Technical Specification 3/4.2.3 - RCS Flowrate and Nuclear Enthalpy Rise Hot Channel Factor

Proposed Change

SUBJECT: Application to amend License VPF-9, revising Tech Spec
 3/4./2.3 re min. measured RCS flowrate. Class III amend fee
 encl.

Attached is a proposed change to the McGuire - Unit 1 Technical Specifications concerning the minimum measured Reactor Coolant System flowrate. This item has been reviewed and it has been determined that there are no adverse safety or environmental impacts associated with the proposed change.

FIGURE 3.23 RCS TOTAL FLOWRATE VERSUS R_1 AND R_2 —FOUR LOOPS IN OPERATION

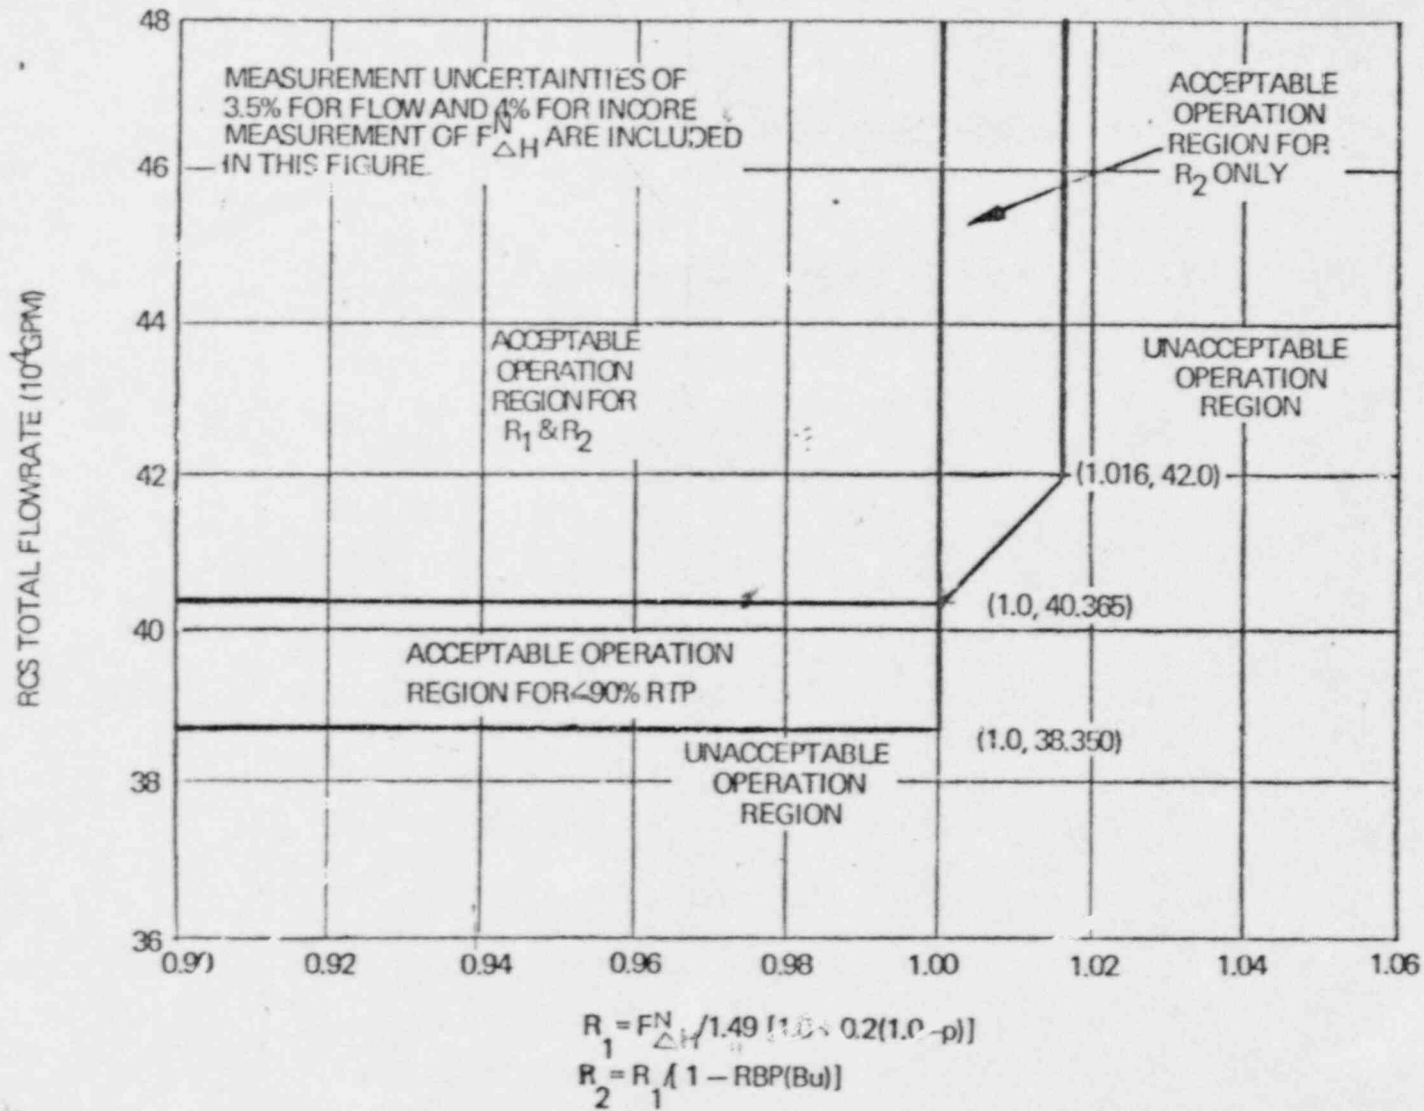
Revise Figure 3.2-3 to lower the minimum Reactor Coolant System flowrate to 383,500 gpm for operation at or below 90% Rated Thermal Power. This value corresponds to 95% of thermal design flow plus measurement uncertainties of 3.5%.

As a result of the above noted relationships and a conservative assumption (based on current indications) that the verified RCS flow will be no lower than 0.95 of Thermal Design Flow it is proposed that McGuire Unit 1 be operated at a maximum power level of 90% of Rated Thermal Power (3070 MWth core power) in the event that measured flow is less than Thermal Design Flow (plus measurement uncertainty).

McGuire Unit 1's Technical Specification limits and accident analyses results have been evaluated to determine the impact of the RCS flow and power reductions. In all cases sufficient margin exists to allow plant operation at the reduced power level. No Technical Specification limits require modification, including core limits, OTAT, OPAT, and Power Range Neutron Flux - High, High setpoint.

The core limits remain the same due to the increased margin to DNB afforded by the power reduction and interpretation that they are now valid for 3070 MWth instead of 3411 MWth. This implies that 3070 MWth should be considered to be 1.0 in fraction of Rated Thermal Power for Figure 2.1-1. With no change in the core limits the OTAT and OPAT trip setpoints remain unchanged. Utilizing the latest Westinghouse data, the uncertainty in the instrumentation for the Power Range Neutron Flux - High trip function is 4.7% span (or 0.6% RTP). With a normal assumption of reactor trip at 109% RTP the uncertainty analysis verifies that a trip will take place at 109% RTP plus 5.6% RTP, or 114.6% RTP. A 5% reduction in RCS flow requires a trip at 115.2% RTP, thus adequate margin exists in the instrumentation such that no change in the nominal setpoint is necessary.
